**REQUEST FOR TENDER**

**CONTRACT NUMBER: C13-01-21**

**Tender for Prequalified Vendors for Interior Office Renovation at 330 Wentworth Avenue North**

**ADDENDUM 3**

CITY OF HAMILTON OPERATION CENTRE RENOVATIONS 300 WENTWORTH ST. N <b>SECOND FLOOR PLAN</b> (REFERENCE:A1.03)	PROJ: 2020-15	<b>GRGURIC ARCHITECTS INCORPORATED</b> Web: www.2gai.com	<b>ADD SK-01</b>
	SCALE: AS NOTED		
	DRAWN: DW		
	DATE: 2021-02-18

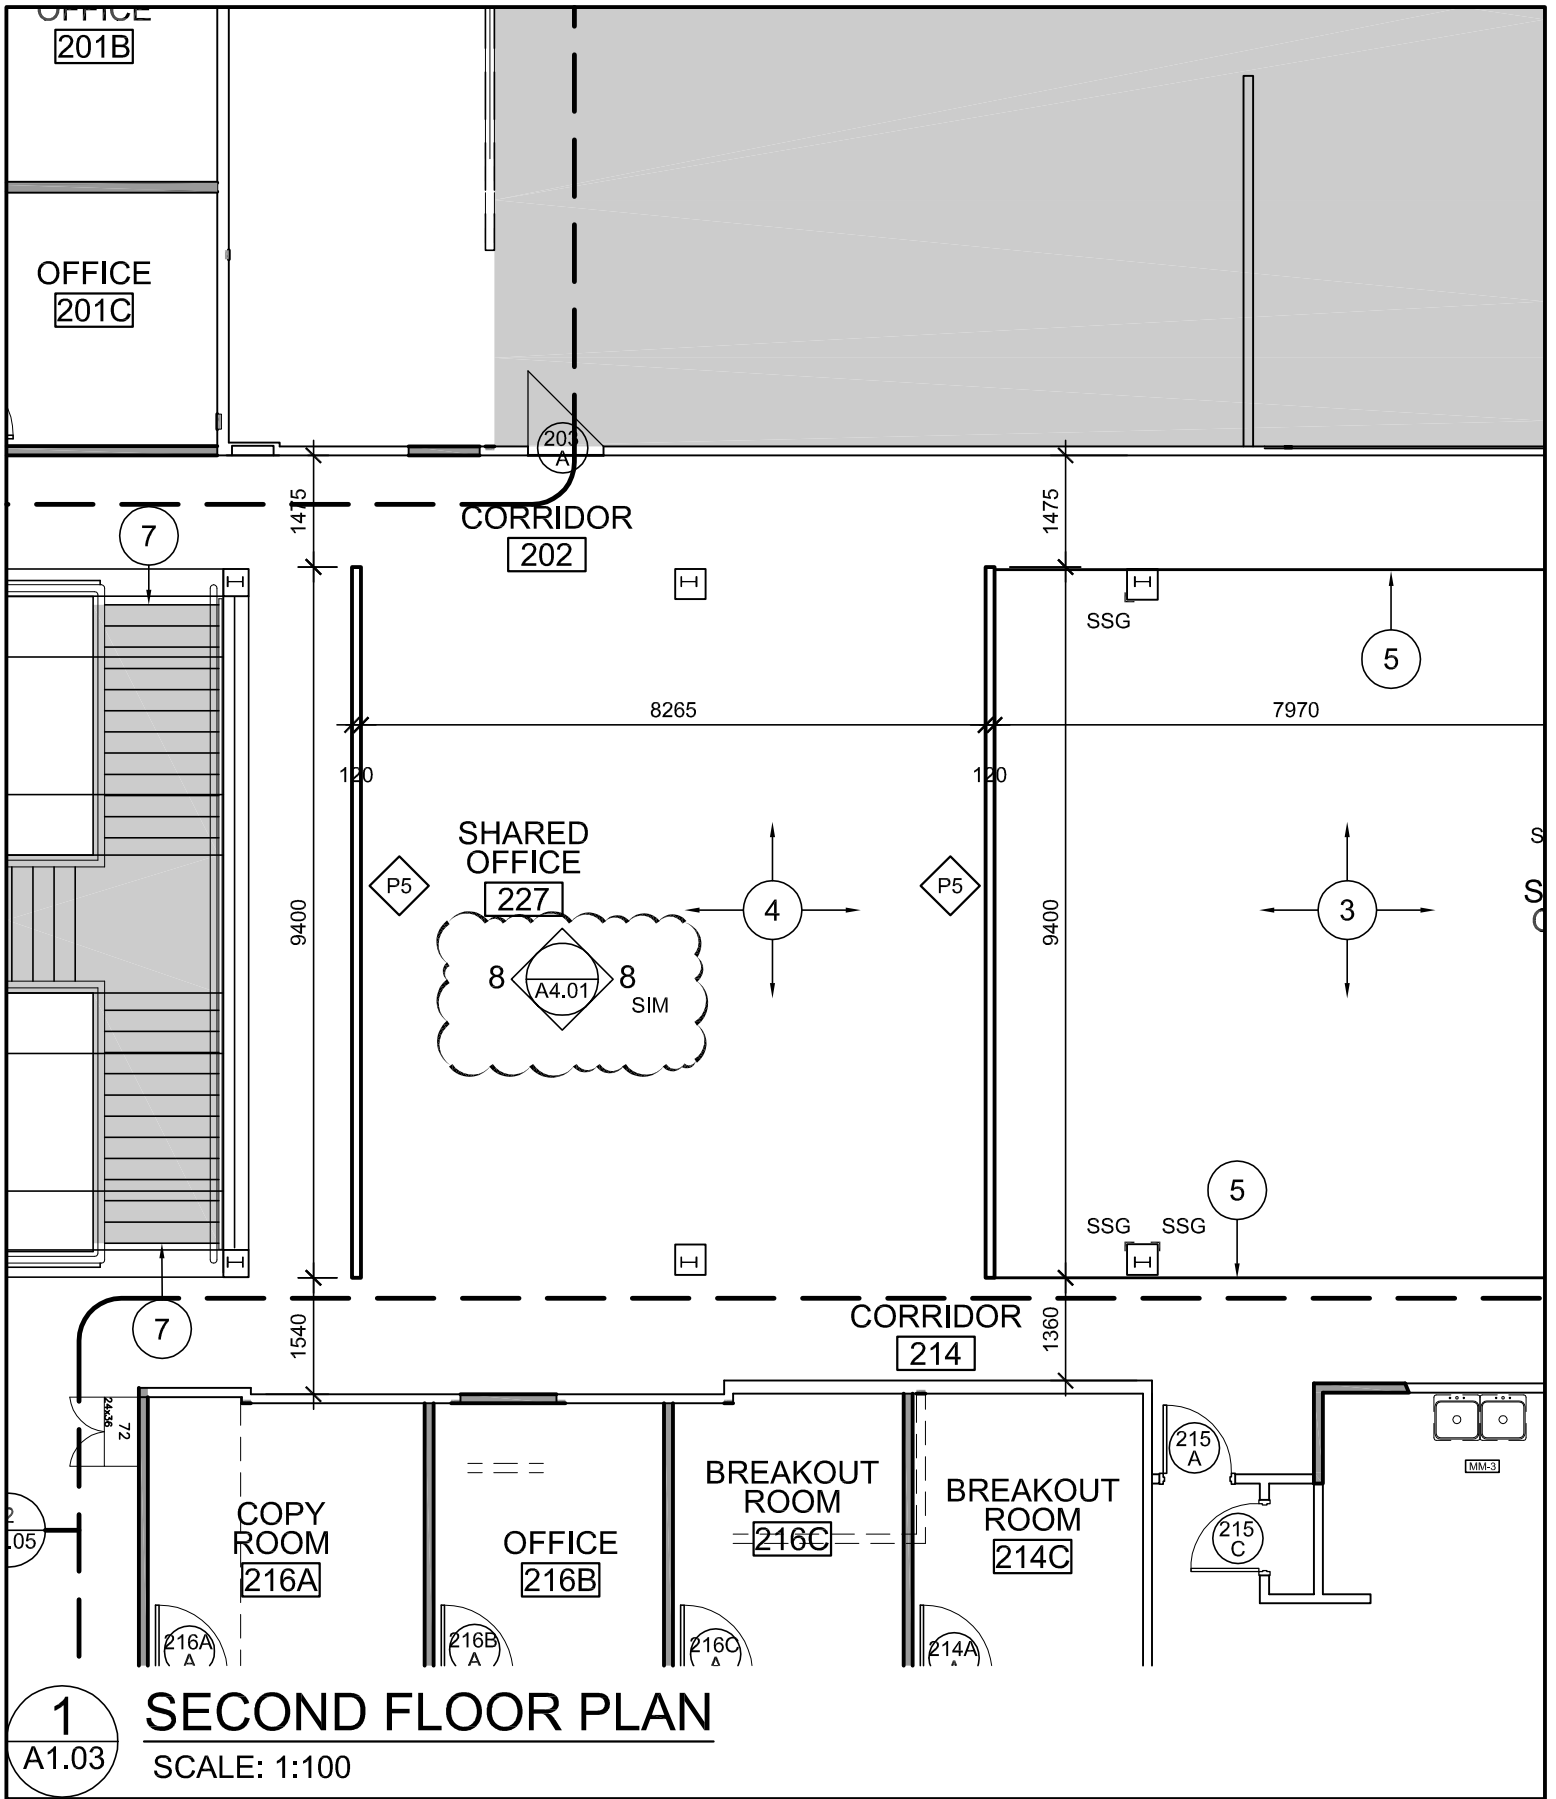
Item 10 On A1.03 – Second Floor Plan, the wall on the east side of room 227 – Shared Office will be similar to the wall on the west side of this room. Refer to attached sketch SK-01 for the updated elevation reference.
